SERVICE INFORMATION NO. SI 22-014

EASA AD No. 2007-0025
ATA-Code: 72-00

CHECKING OF THE CRANKCASE ON ROTAX® ENGINE TYPE 912 AND 914 (SERIES)

SB-912-029 R3

see fig. 1

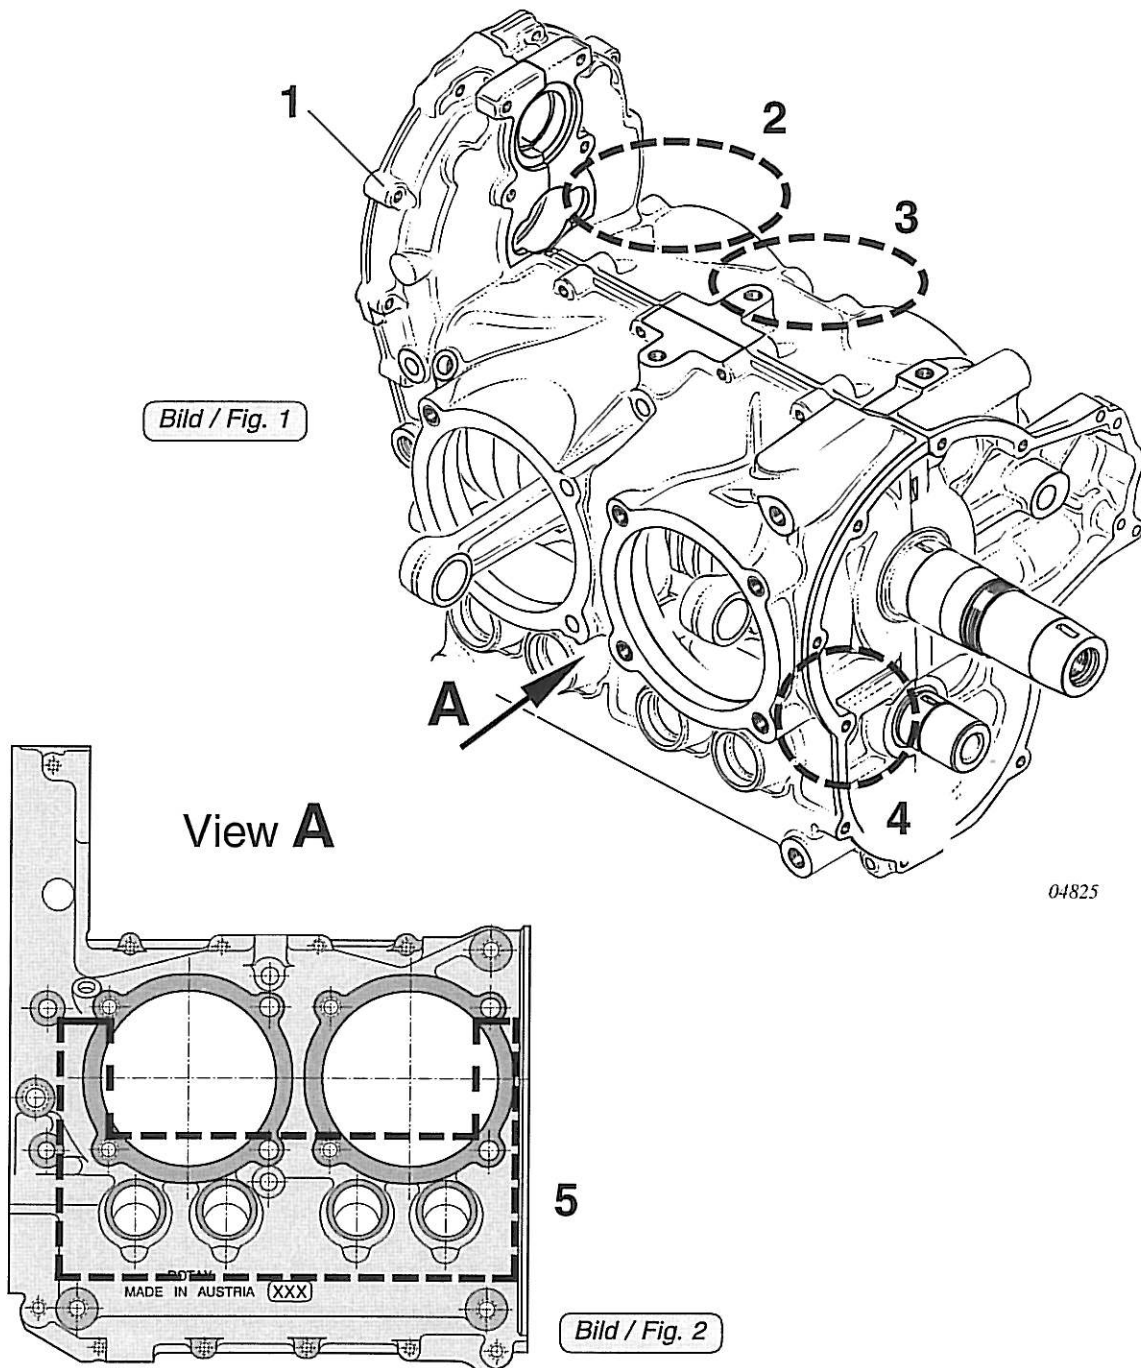
- Visually inspect the crankcase (1) and engine suspension for cracks in accordance with the relevant Maintenance Manual.

Visually inspect the crankcase especially:

- in the area of cylinder 1 upper side (2)
- between cylinder 1 and 3 upper side (3)
- in the area of cylinder 4 lower right side (4) and
- detailed inspect in the area (5). See view **A** fig. 2.

For those engines using the ROTAX[®] cooling air baffle. Visually inspect for oil leaks in area (2) and (3). If leaks are found, then further investigation to determine the cause of the oil leak is required. If the exact origin of the leak can not be determined i.e. governor, then removal of the cooling air baffle must be required.
